Company: Horizons Regional Council

Project No. 820.V30005.01757

**RE: APP-2006012018.03 – Karioi Wood Processing
Contaminated Land Section 92 Response Technical Review**

Figure 3: Concept Wetland Design (sourced from Babbage RAP Rev 2, 10 June 2026)

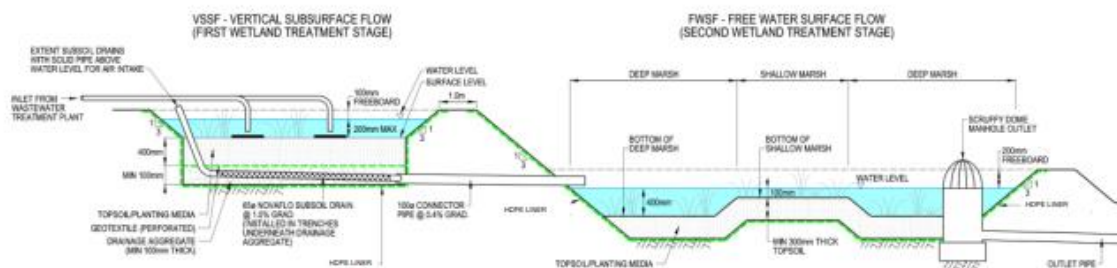
Rev2 of the RAP confirms that visible pieces of observed anthropogenic material, such as concrete, rubber, wood and plastic will be separated and not used as part of the fill material. Following all soil profiling works, it is understood that the surface will be lined with a HDPE liner across the wetland, with no site sourced soil used on top of the HDPE liner for wetland finishing or landscaping. Refer to **Figure 3** for a concept design of the proposed wetland.

Following profiling, and all cut and fill works, all soils (whether contaminated or not) will be encapsulated under a HDPE liner. The chosen liner is understood to have a hydraulic conductivity in the range of 10^{-12} to 10^{-15} m/s, with the wetland designed to

achieve near-zero seepage provided the liner is correctly installed and quality assured.

The proposed wetland development and remediation strategy relies on the encapsulated soil not becoming saturated such that remnant pulp within soil could degrade anaerobically and generate methane. Installation of the HDPE liner with appropriate QA is the primary method of ensuring the soils underlying the wetland do not become saturated. It is understood that the wetland design is not yet finalised, however, it is unclear on how it will be known that the liner is not leaking condensate from the wetland into the subsurface. A leak monitoring system should be considered into the wetland design.
